<b>JRPP No:</b>	<b>2011SYE090</b>
<b>DA No:</b>	<b>DA11/0763</b>
<b>LGA:</b>	<b>Sutherland Shire</b>
<b>Proposed Development:</b>	<b>Demolition of Existing Buildings and Construction of a Nine (9) Storey Mixed Use Development Comprising 27 Residential Apartments Above Ground Floor Retail/ Restaurant Tenancies &amp; Three (3) Level Basement</b>
<b>Site/Street Address:</b>	<b>Nos. 19 and 21 Gerrale Street, Cronulla Part Lot 21 DP 4759 and Whole of SP394</b>
<b>Applicant:</b>	<b>Sammut Developments</b>
<b>Submissions:</b>	<b>212 (87 objections, 125 in support)</b>
<b>Recommendation:</b>	<b>Deferral of Decision</b>
<b>Report By:</b>	<b>Luke Murtas, Acting Team Leader Sutherland Shire Council</b>

## Assessment Report and Recommendation

*Figure 4: Typical floor plate, Belgrave Apartments.*

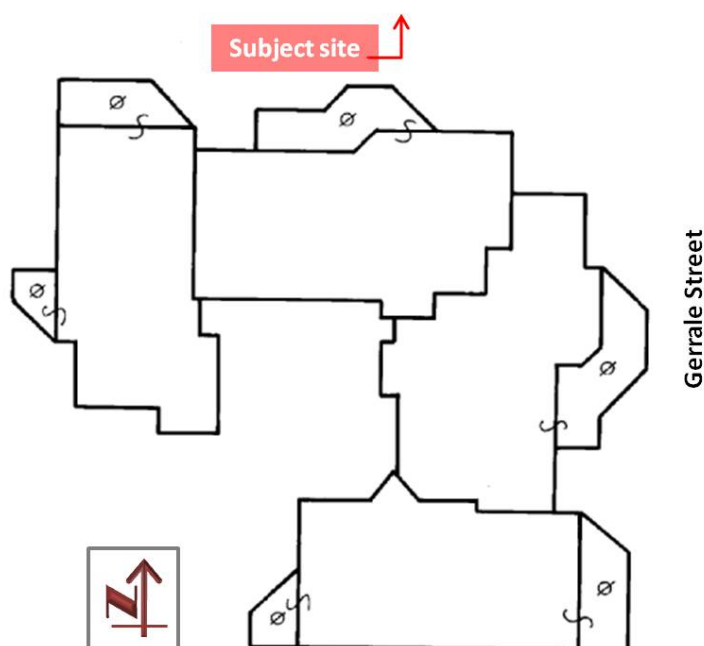
In the *Belgrave* adjoining to the south, 14 of the 29 apartments (2 each at Levels 1-6 and 1 each on Levels 7 and 8) face northward and have their balconies and living areas oriented north across the subject site. An indicative layout plan (taken from the strata plan) of Levels 1-6 is below:

*Figures 5 -7: 8am-4pm hourly midwinter shadow analysis supplied by the applicant (the top images show the impact looking from the east and the bottom images from the west).*

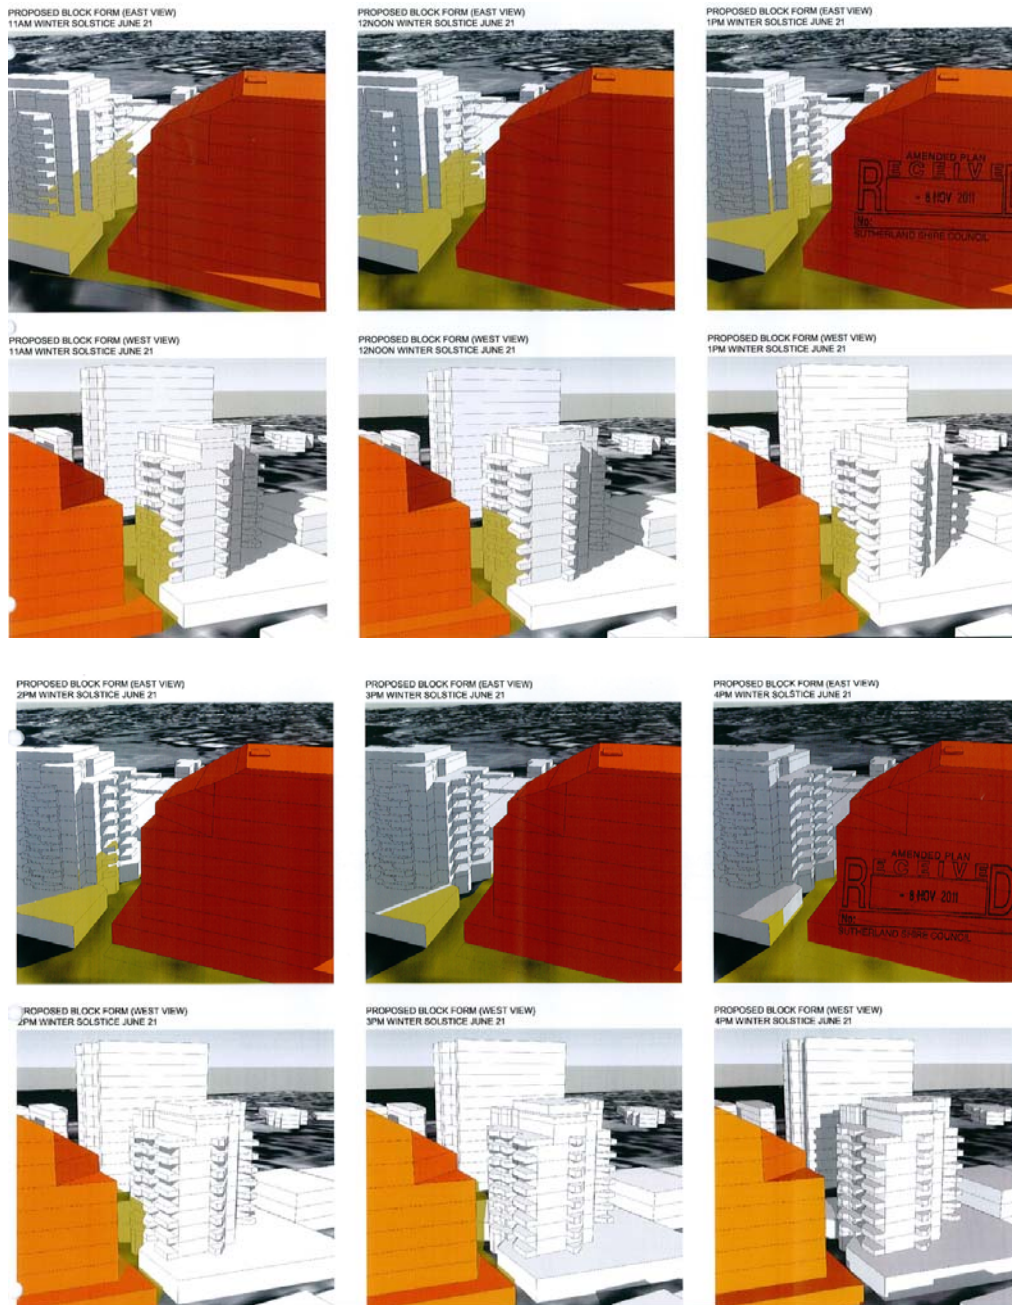
Internally, only 15 of 27 proposed apartments (56%) receive 3hrs or more of sunlight between 9am-3pm on midwinter. However, 21 of 27 apartments (78%) receive more than 2hrs of sunlight in the same period. This is not optimal for a new building on a relatively unconstrained site. Whether the building complies with the applicable standard will depend on whether the 2hr or the 3hr standard is ultimately adopted.
